## PRELIMINARY SITE PLAN

## GRANDVIEW

SINGLE-FAMILY CONDOMINIUM COMMUNITY  
ROCHESTER HILLS, OAKLAND COUNTY, MICHIGAN

REVISION: Revision #6

SHEET NO. 1

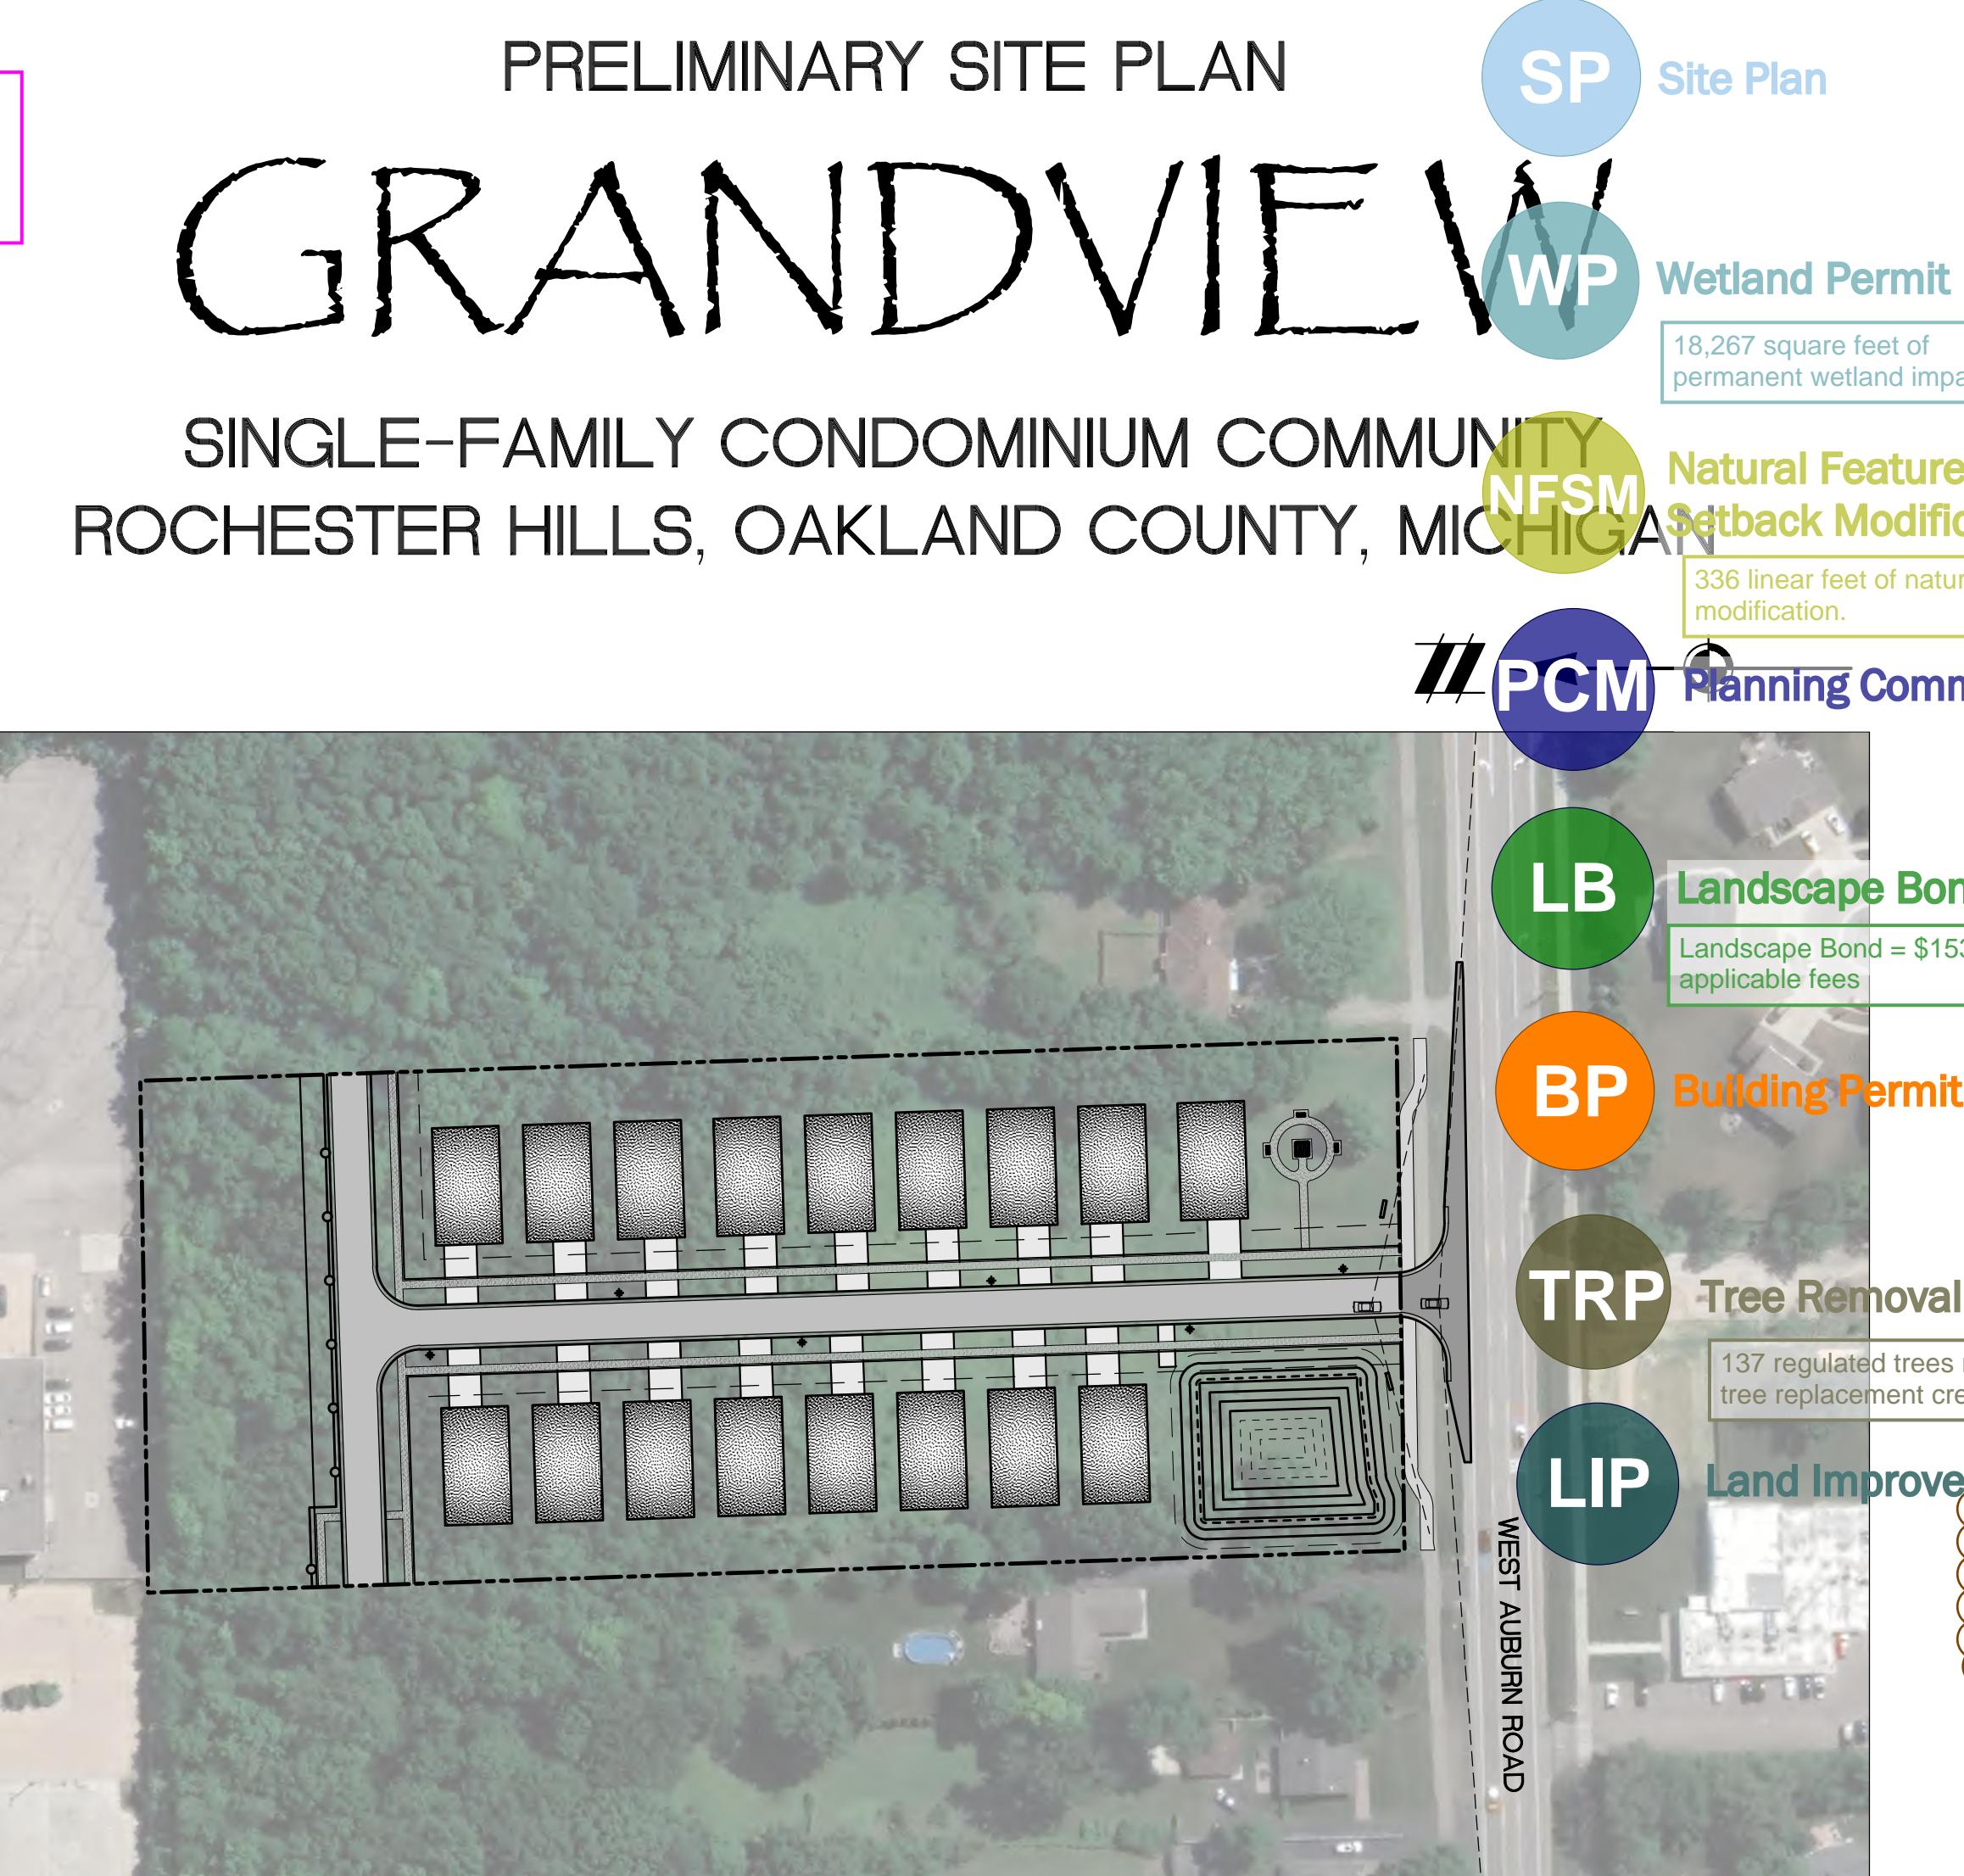
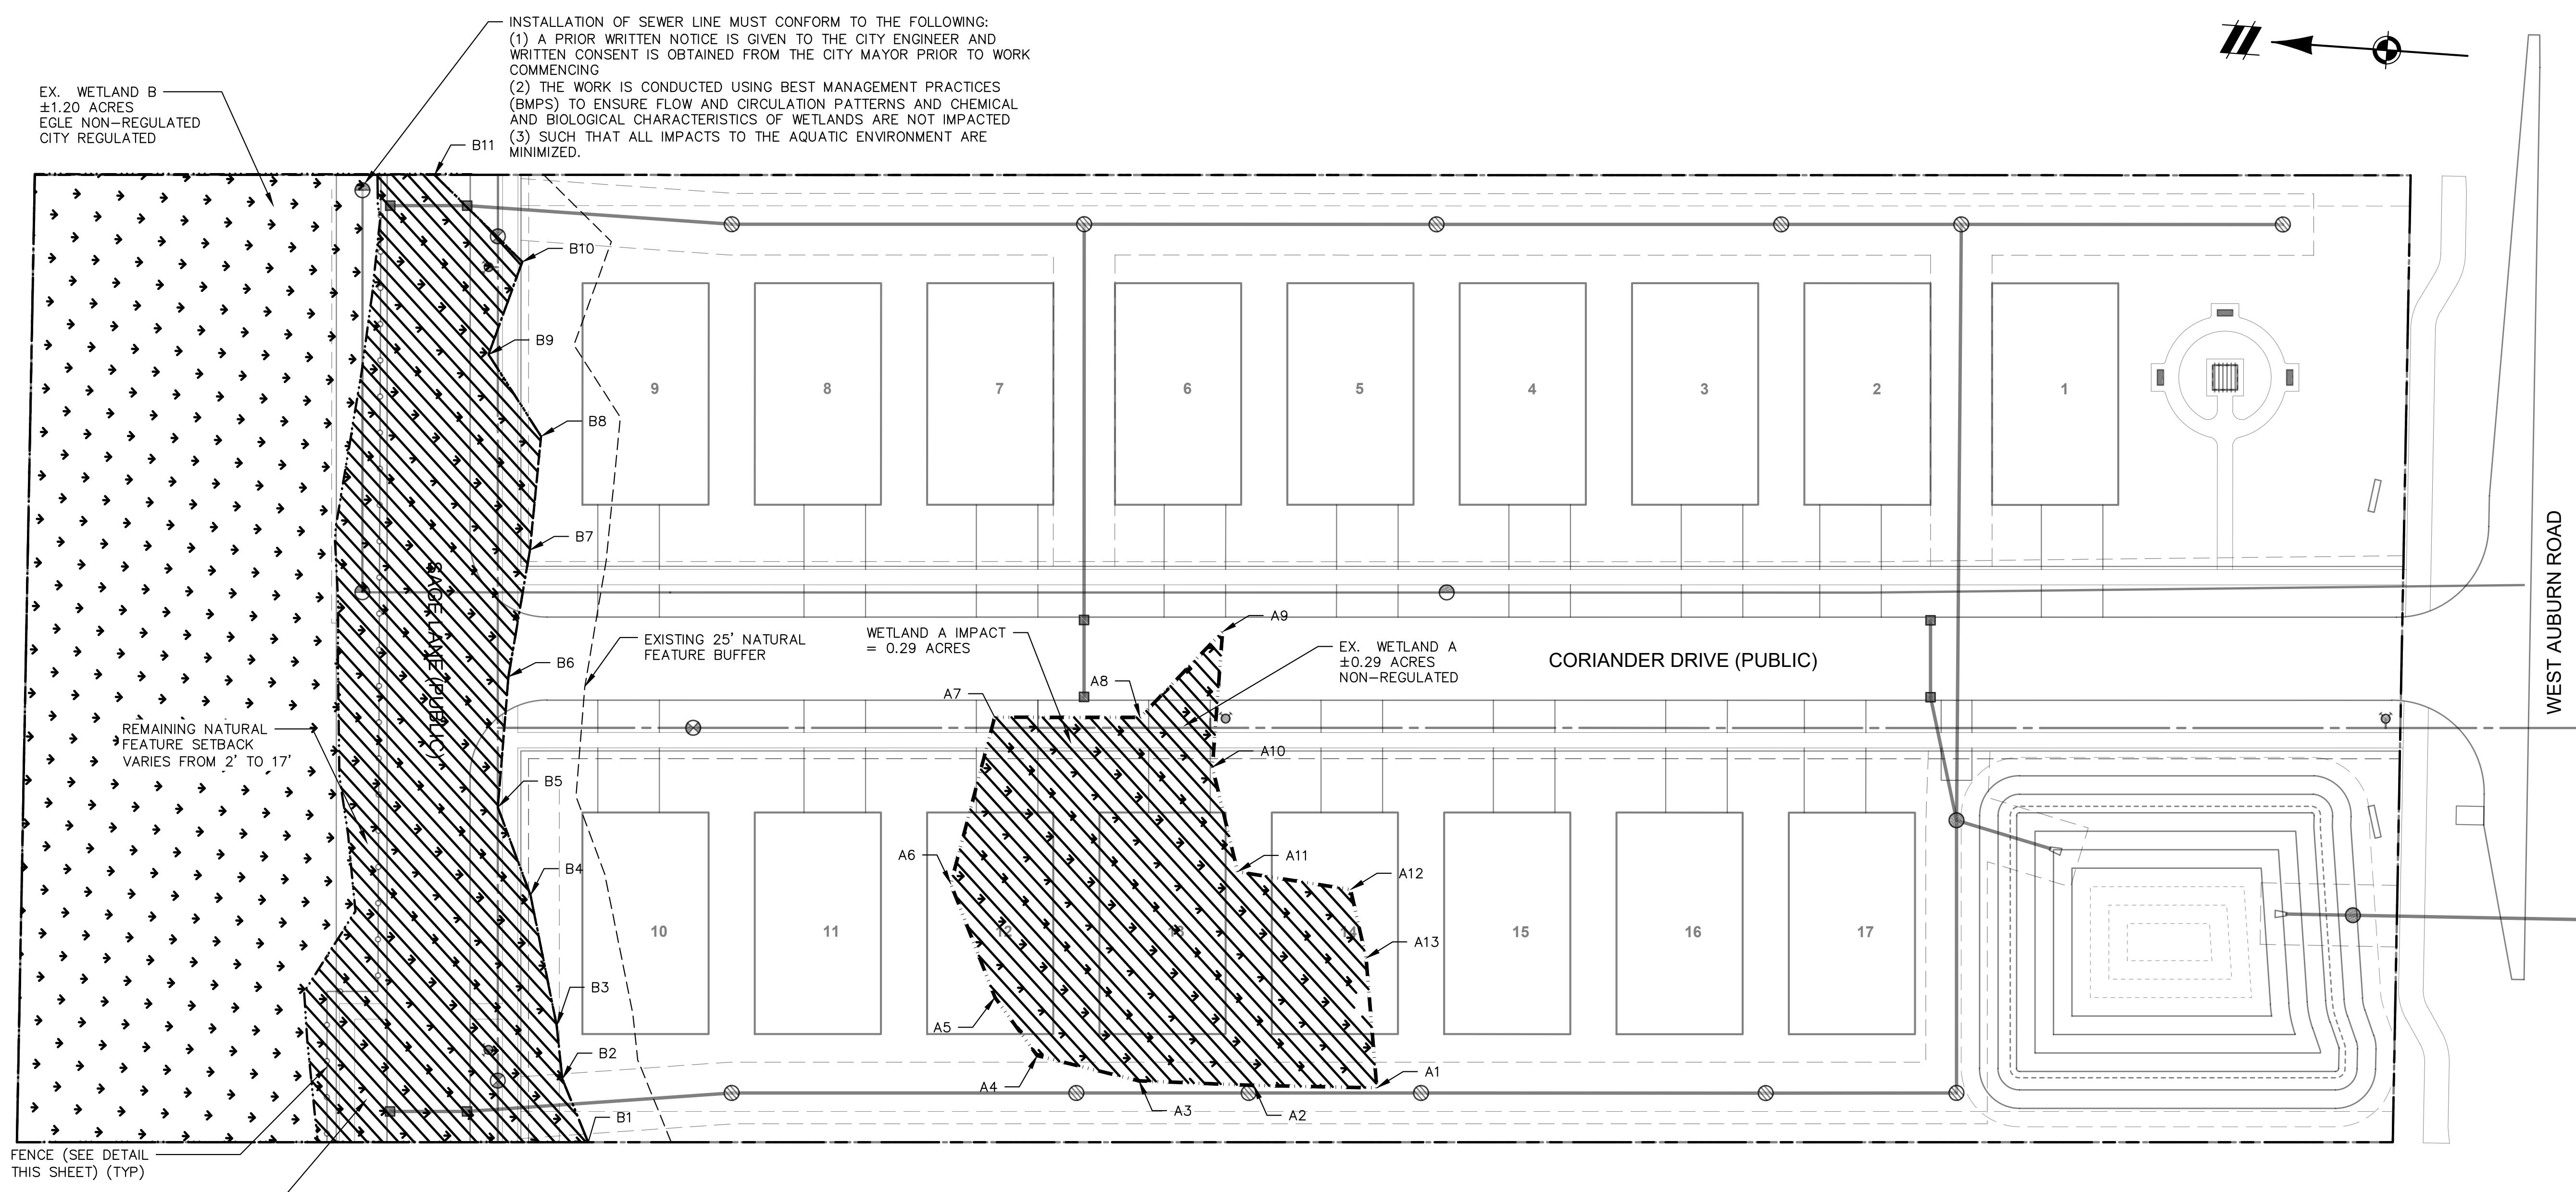
Provide a topo survey sheet  
with professional surveyor  
seal and signature.
